# Site Accessibility Evaluation

**Taco Bell Store #015908  
(Pre)**

**940 N Leavitt Rd  
Amherst, OH 44001**

**Pre Inspection**

### Finding: 20

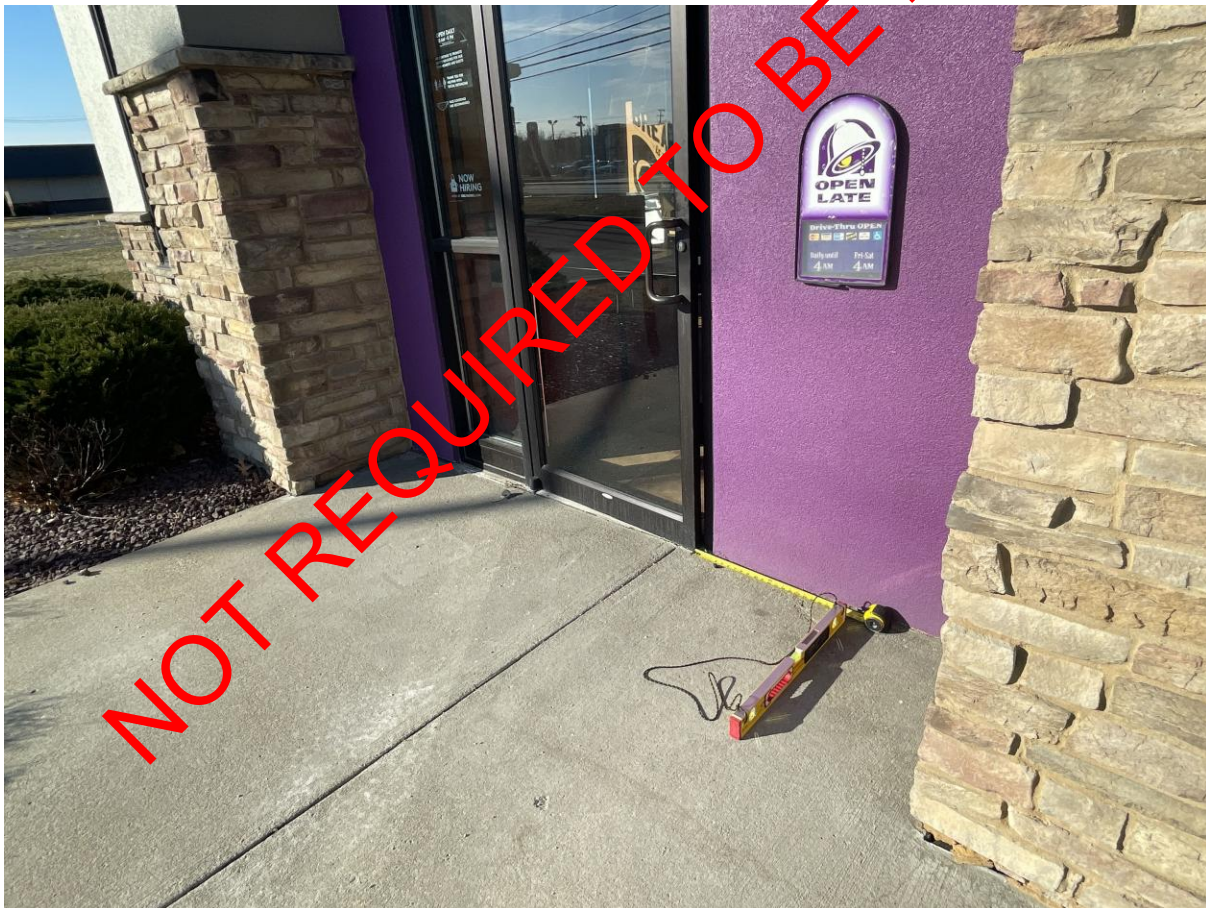
The maneuvering clearance at the entrance door exceeds 2% slope.

Exterior doors with a front approach must have a landing on the pull side that is a minimum of 60 inches in depth perpendicular to the door in a close position by a minimum width dimension of 18 inches plus the door width. The additional 18 inches must extend past the door on the latch side. The entire maneuvering clearance must be free of obstructions and must be flat (2% max. slope is considered flat in any direction).

2.5%-2.8%

WITHIN REASONABLE CONSTRUCTION TOLERANCE

NOT REQUIRED TO BE MODIFIED
